## **REMOVAL OF YORI GROVE DRAIN AT EAST TAYLOR ROAD AND AMENDMENT OF THE EAST SAN JOAQUIN WATER QUALITY COALITION MONITORING SCHEDULE**

SUBJECT: REQUEST TO REMOVE YORI GROVE DRAIN MONITORING SITE AND AMEND MONITORING SCHEDULE FOR LEVEE DRAIN – EAST SAN JOAQUIN WATER QUALITY COALITION

Figure 1. Yori Grove Drain at East Taylor Road, and Levee Drain at Carpenter Road site subwatershed map.

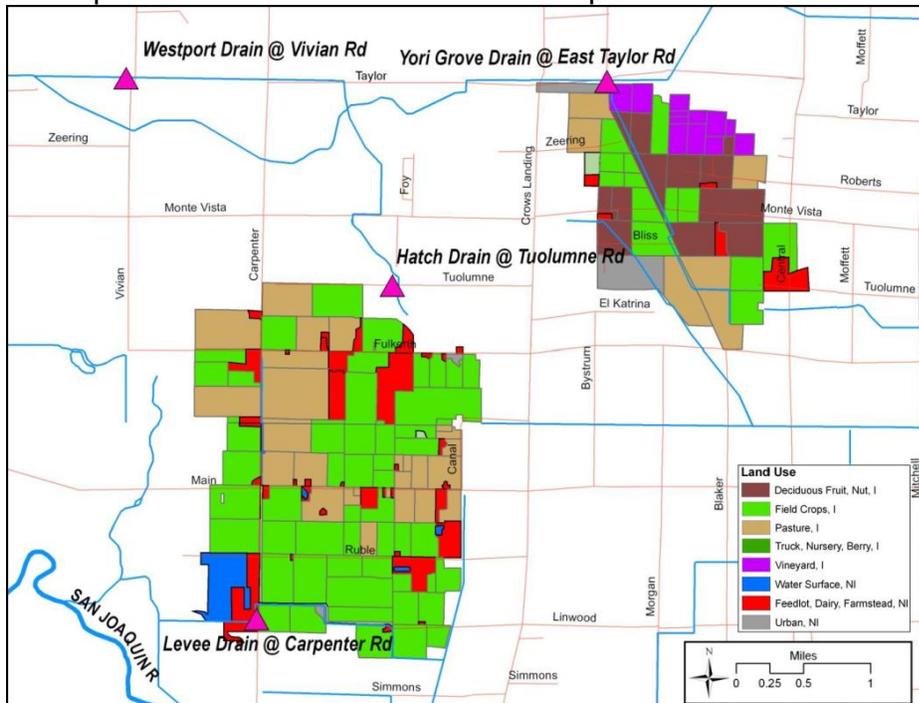
The California Regional Water Quality Control Board, Central Valley Region received a request from the East San Joaquin Water Quality Coalition (Coalition) on 28 December 2011 to modify its Monitoring and Reporting Program Plan (MRP Plan). The Coalition proposes to remove the current monitoring site Yori Grove Drain at East Taylor Road from the MRP Plan, and to monitor Levee Drain at Carpenter Road instead (Figure 1).

The Coalition Zone in which Yori Grove Drain is located (Zone 2) will be characterized by nine other Assessment Monitoring locations identified in the Coalition's MRP Plan that are scheduled to be sampled based on a rotation schedule. Based on the site information in the MRP Plan, Yori Grove Drain subwatershed represents 1,226 irrigated acres; the land use includes deciduous fruits/nuts, vineyard, field crops, pasture and dairy (urban land is also found within the site subwatershed). Levee Drain at Carpenter Road is located to the south and west of the TID Lateral #3 monitoring location, and discharges directly to the San Joaquin River. Levee Drain subwatershed encompasses 2,500 irrigated acres, and the land use upstream of the sample site to the north and east includes truck/nursery/berry crops, pasture and dairy.
